DRAINAGE CERTIFICATION

| PROJECT TITLE: NORTH DOMINGO BACA MULTIGENERATIONAL CENTER - PHASE II 7521 CARMEL AVE. NE ALBUQUERQUE, NEW MEXICO 87113 | | | |
| DRAWING TITLE: GRADING AND DRAINAGE PLAN | | | |
| CITY PROJECT NO. 7136.93 | | ZONE MAP NO. C-19-Z | DWG. C-202 |

GRADING AND DRAINAGE PLAN

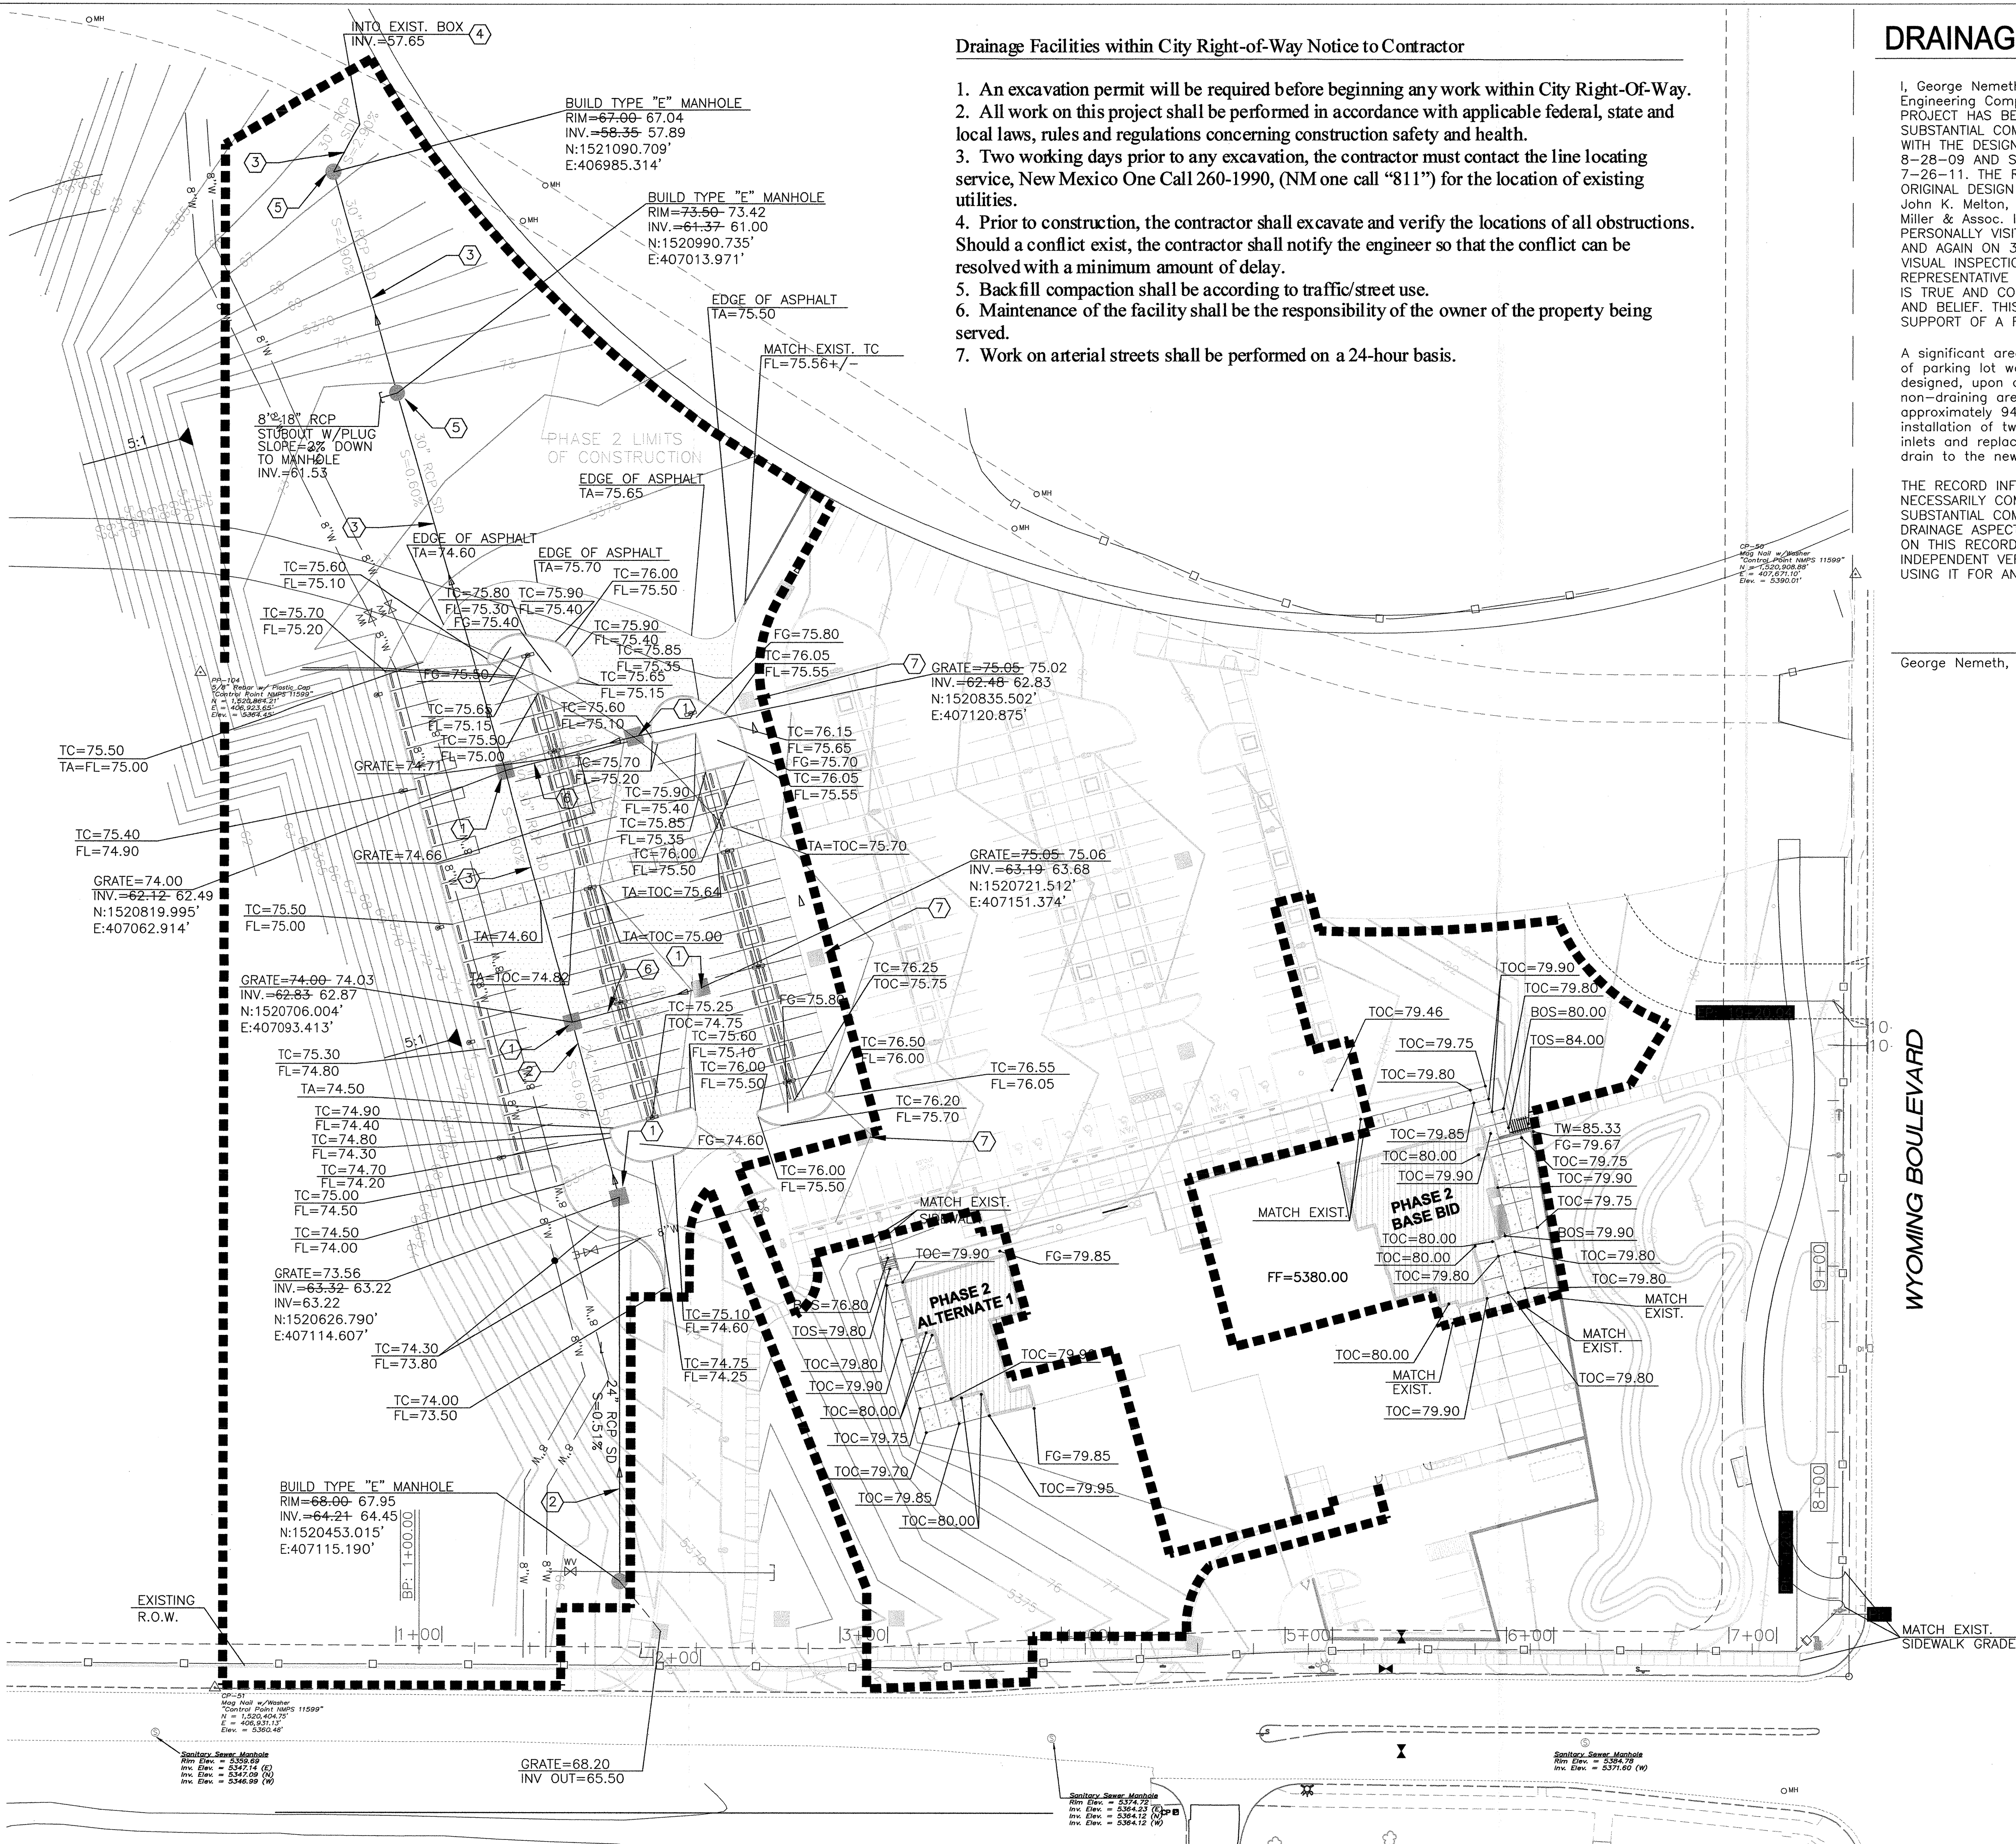
A significant area, approximately 700 square feet (SF), of parking lot was not draining to the drain inlets, as designed, upon completion of construction. The non-draining area was fixed by the removal of approximately 940 SF of asphalt pavement, the installation of two new traffic rated, pedestrian drain inlets and replacement of the asphalt with grading to drain to the new inlets. The area now drains properly.
